Model: MT-C5	Date: 17-May -12	No.: RD131001a
--------------	------------------	----------------

Subject: Firmware Release Note: RPCS		Prepared by: M. Yoneda	
From: 2nd Tech Service Sect., MFP/Printer Tech Service Dept.			
Classification:	<input type="checkbox"/> Troubleshooting <input type="checkbox"/> Mechanical <input type="checkbox"/> Paper path <input type="checkbox"/> Product Safety	<input type="checkbox"/> Part information <input type="checkbox"/> Electrical <input type="checkbox"/> Transmit/receive <input checked="" type="checkbox"/> Other (Firmware)	<input type="checkbox"/> Action required <input type="checkbox"/> Service manual revision <input type="checkbox"/> Retrofit information <input checked="" type="checkbox"/> Tier 2

This RTB has been issued to announce the firmware release information for the **RPCS**.

45. Fusing unit 2 (D131/D132/D133)

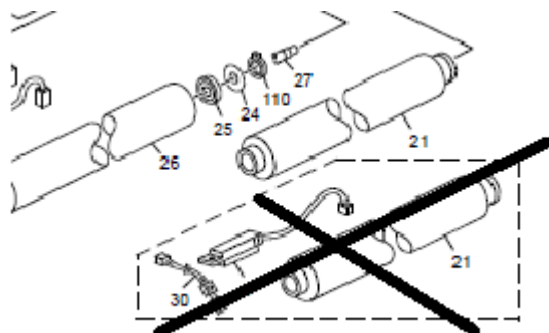
Change/Reason: The part numbers are wrong and the model is clarified.

Old part number	New part number	Description	Q'ty	Page	Index	Note
D1314001	D1314584	Fusing Unit:NA:Ass'y	1	105	*	D131/132 (NA)
D131 4003	D1314587	Fusing Unit:M-C5:EU:Ass'y	1	105	*	D131/132 (EU)
D133 4001	-	Fusing Unit:D133:Ass'y	1	105	*	D133 (NA/EU)
D131 4080	-	Stripper Pawls:Open And Close:Ass'y	1	105	1	D131/132
D133 4080	-	Stripper Pawls:Open And Close:Ass'y	1	105	1	D133
B065 4135	-	Fusing Entrance Plate - 240V	1	105	22	D133 (NA/EU)
D062 4131	-	Fusing Entrance Guide Plate: NA:Ass'y	1	105	22	D131/132 (NA)
D062 4135	-	Fusing Entrance Guide Plate: Lower:Ass'y	1	105	22	D131/132 (EU)

46. Fusing unit 4 (D131/D132/~~D133~~)

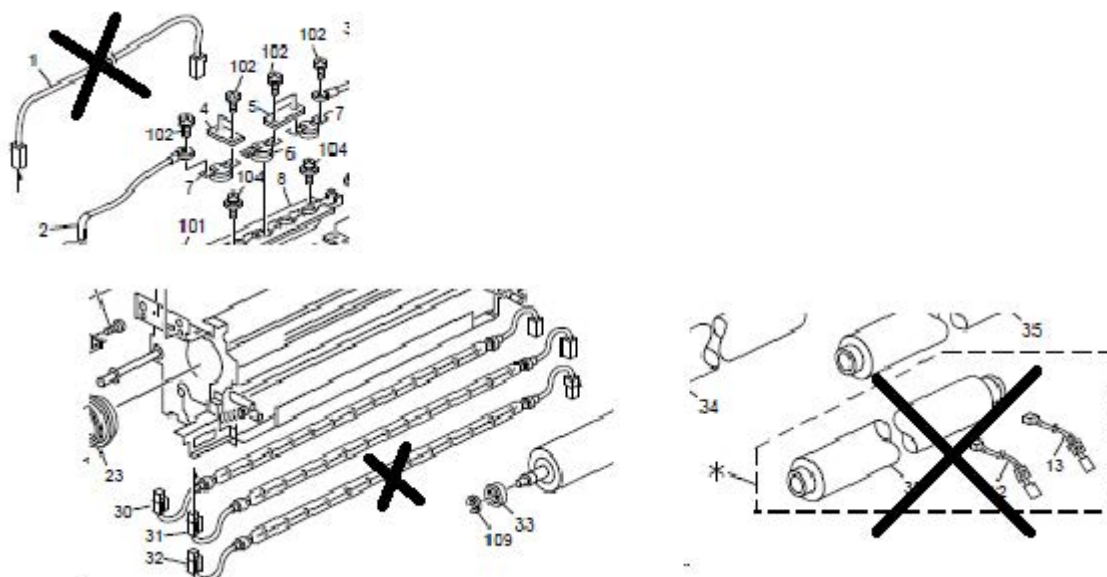
Change/Reason: The picture is wrong. There is no part under the cross.

Change/Reason: The parts are not for the D131/132 models. The correct part numbers are in the following table. The part numbers are wrong and the model is clarified.

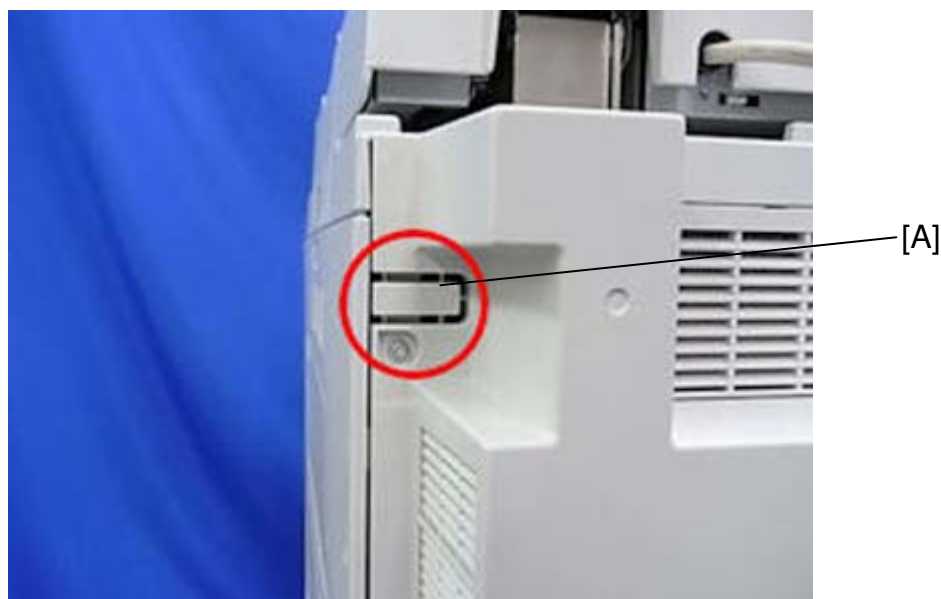
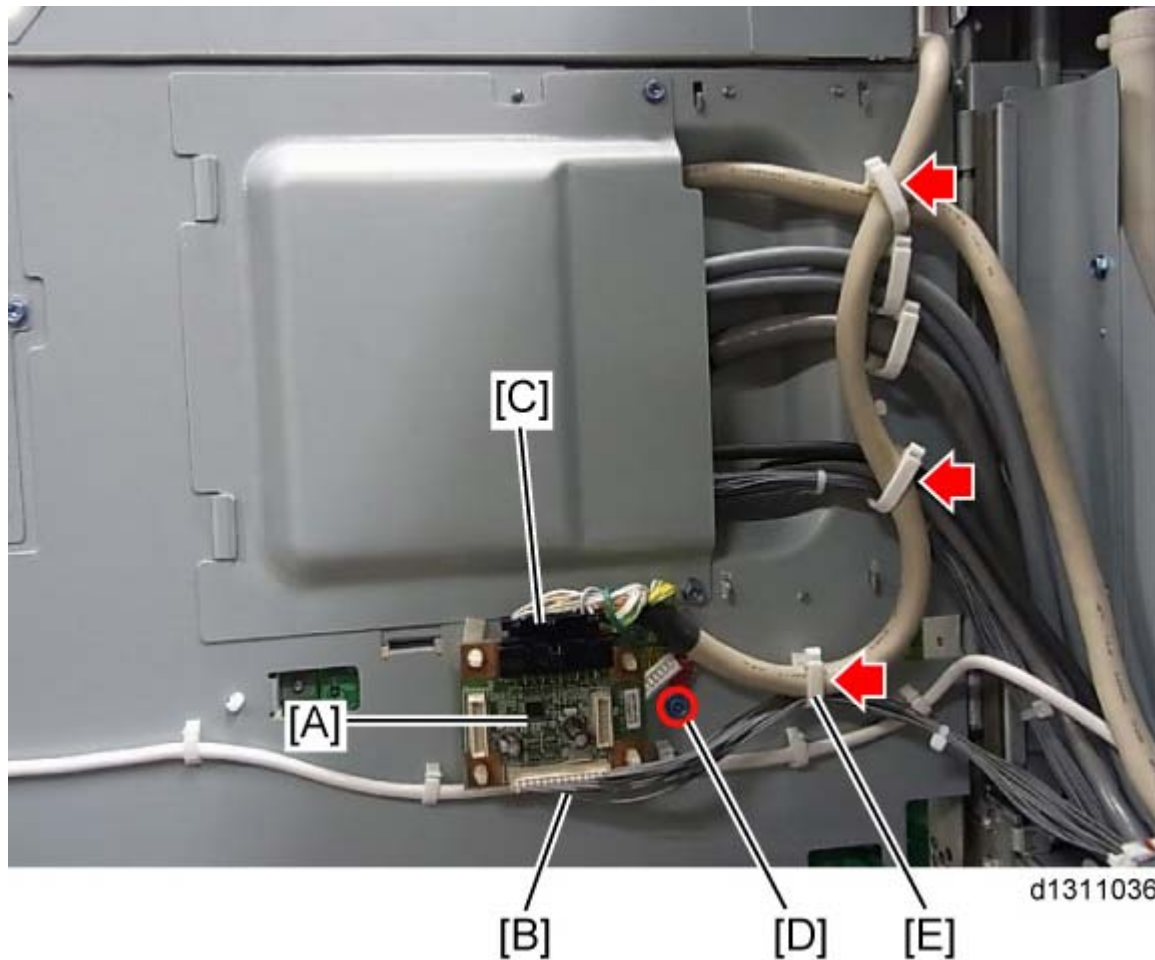
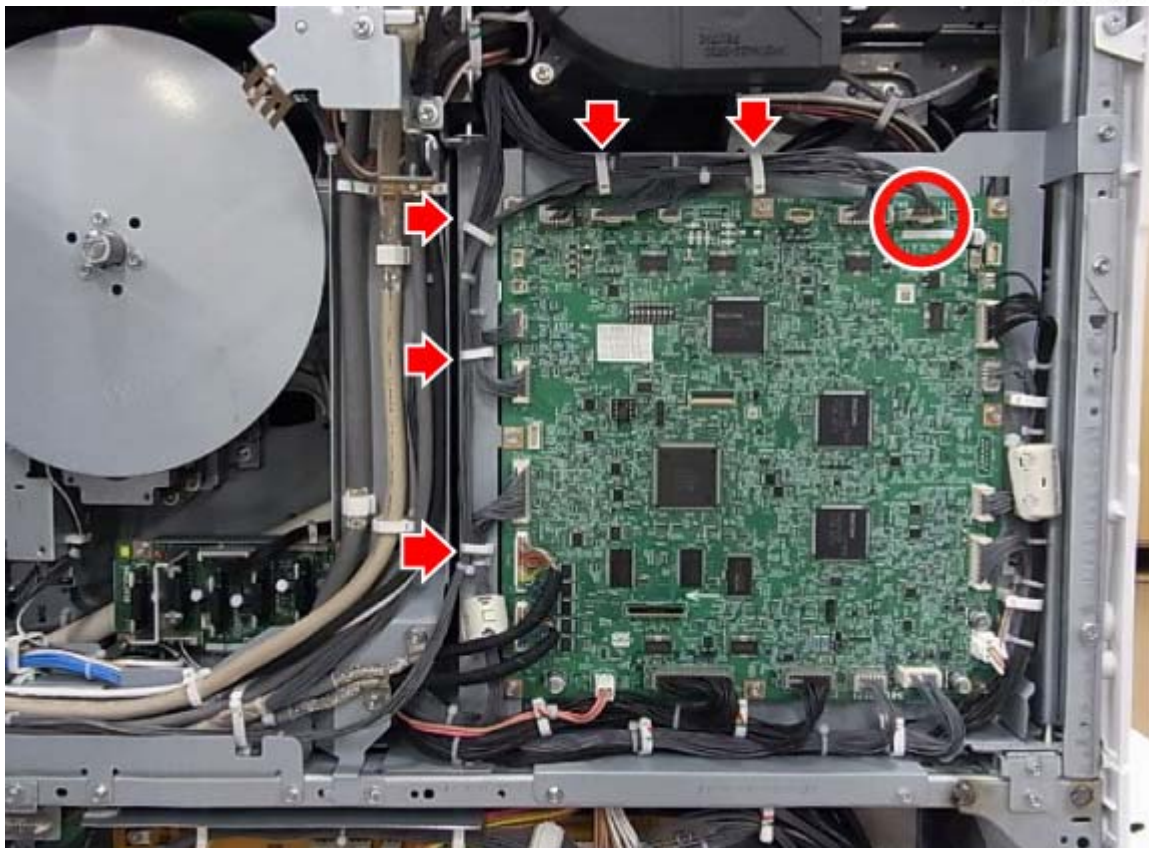
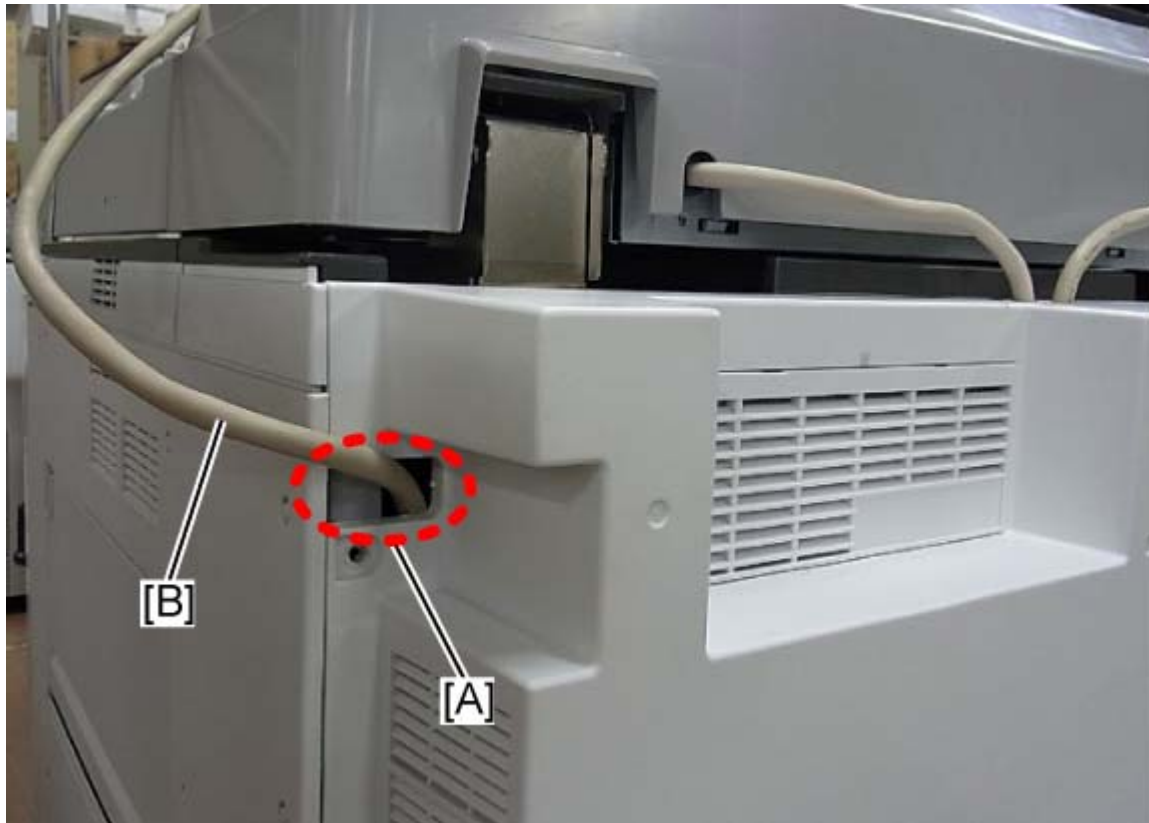
Add the following procedure for the installation of the key counter interface.

1. Remove the rear cover, and then cut away the small plate [A].

2. Open the controller box.
3. Attach the board [A].
4. Connect the connector [B] to CN003.
Note: The harness with connector [B] is located inside mainframe paper tray 3.
5. Connect the key counter harness [C] to CN004.
6. Attach the ground wire [D].
7. Clamp the harness at the three points marked by the red arrows in the photo.
Note: Key counter harness: three points, Harness in the tray 3: 1 point

11. Lead the harness [B] for the key counter through the hole [A], and then reattach the rear cover.

SYMPTOM

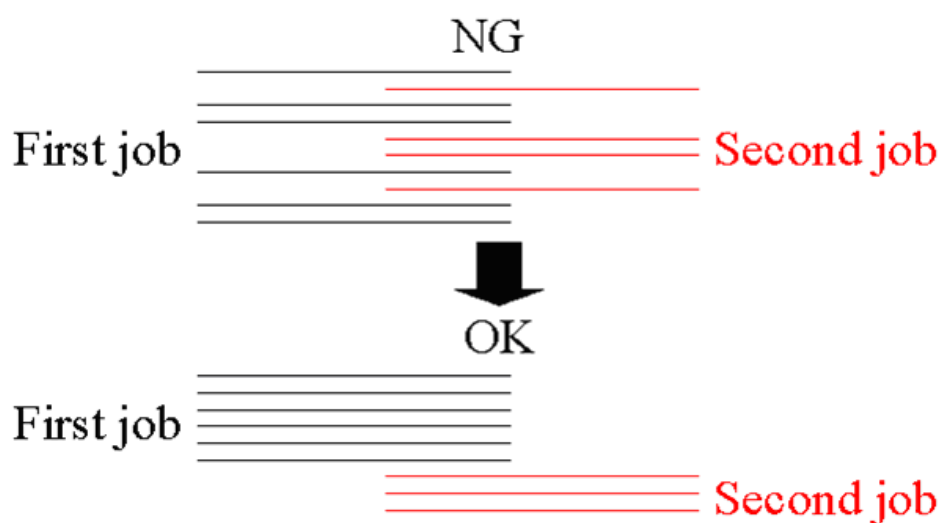
Pages from two separate faxes are printed out in the wrong order if one is received (via one line) while the other has already started to print out (having been received via another line).

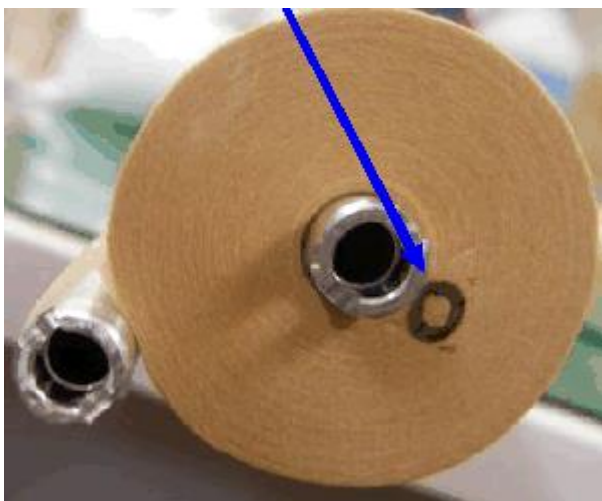
Change: The amount of oil in the cleaning web was increased.

The **new web** (AE045069) is marked with a circle as shown below.

74.Frame Section 4 (D131/D132/D133)

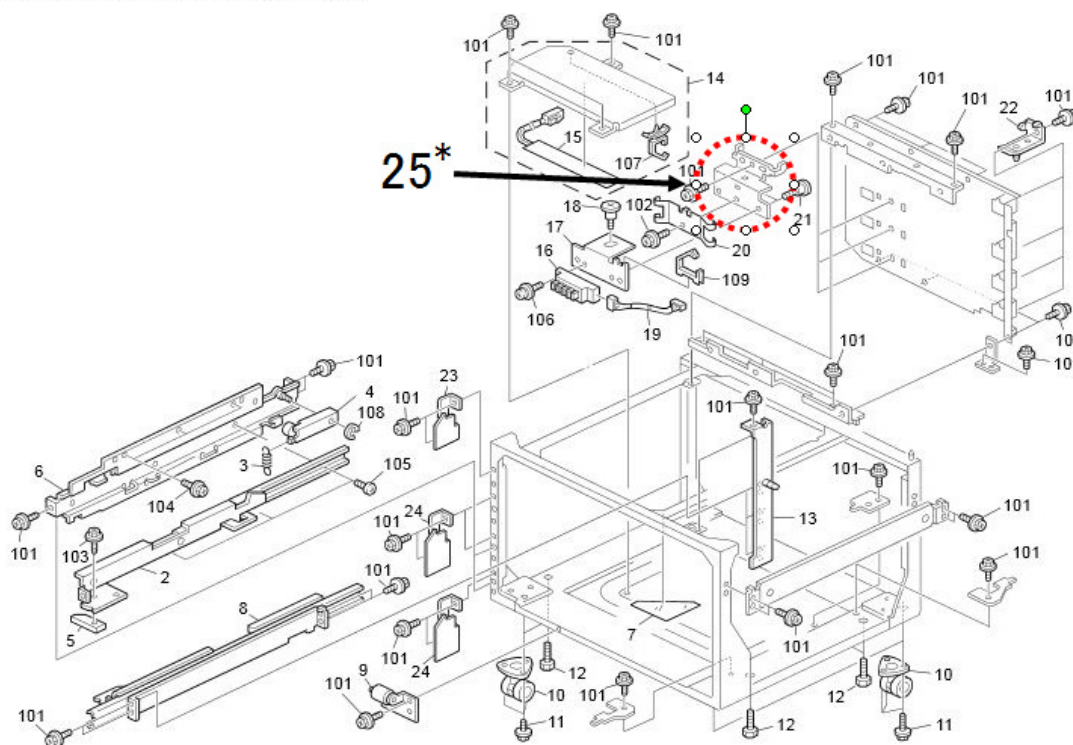
Change/Reason: The following was missing from the Parts Catalog.

New part number	Description	Q'ty	Int	Page	Index	Note
D0626640	BRACKET:SENSOR:PAPER SIZE SENSOR	1		162	25*

69.Electrical Section 8 (D131/D132/D133)

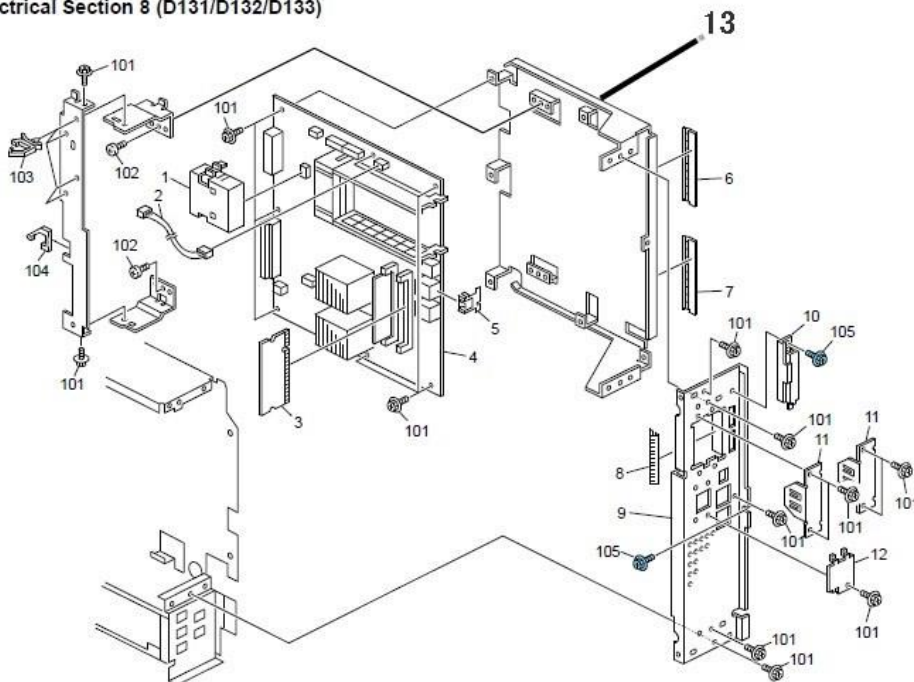
Change/Reason: The following part was missing from the Parts Catalog.

New part number	Description	Q'ty	Int	Page	Index	Note
D0625852	BRACKET:CONTROL BOARD	1		152	13*

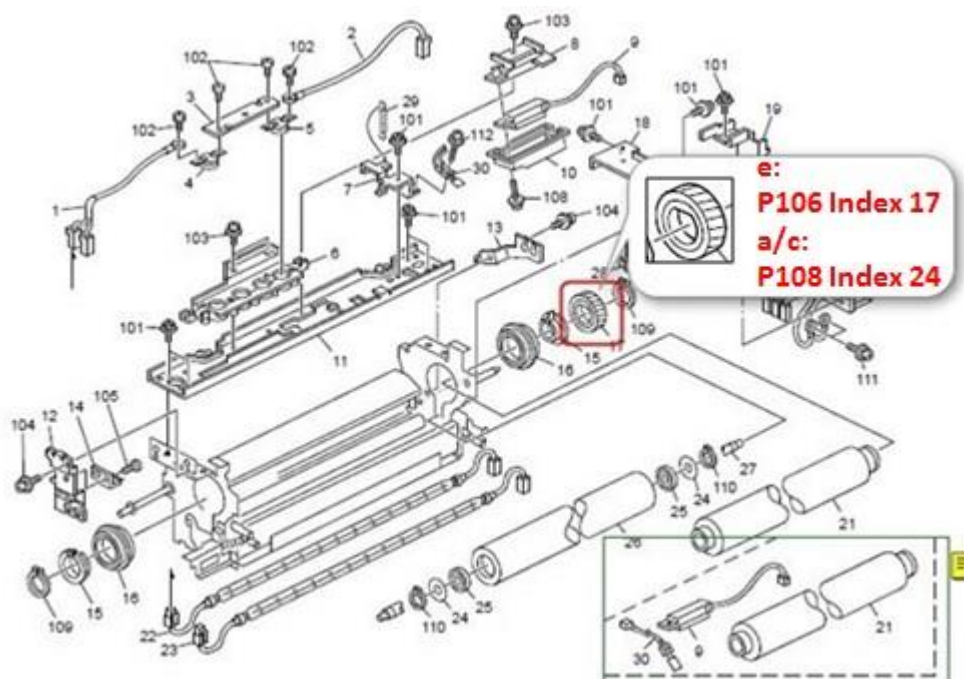
Change: The illustration was revised.

Reason: To clarify the model(s) for each part, as per a request from the field.

part number	Description	Page	Index	Note
AB012062	GEAR:HOT ROLLER	108	24

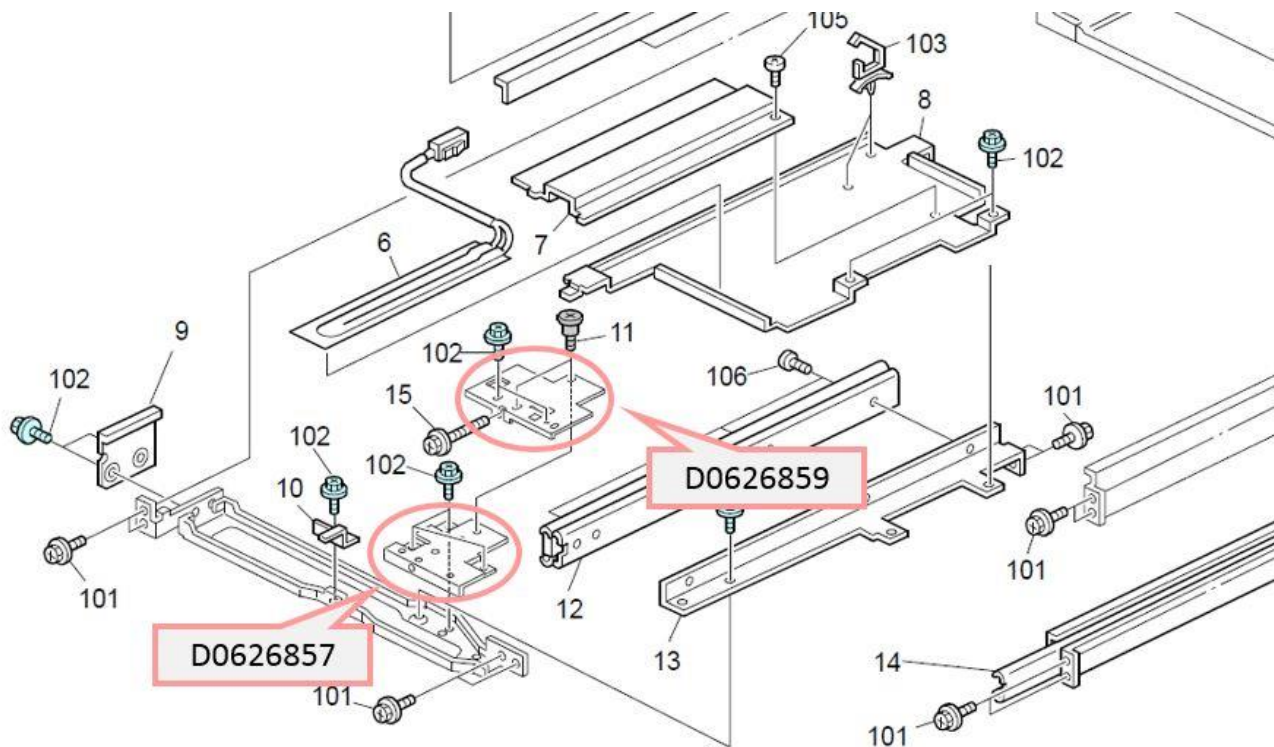
Change/Reason:

The following parts were missing from the Parts Catalog.

Part number	Description	Q'ty	Int	Page	Index	Note
D0626857	BRACKET:HOLDER:STOPPER:TANDEM LCT	1	-	164	-	-
D0626859	HOLDER:STOPPER:TANDEM LCT	1	-	164	-	-
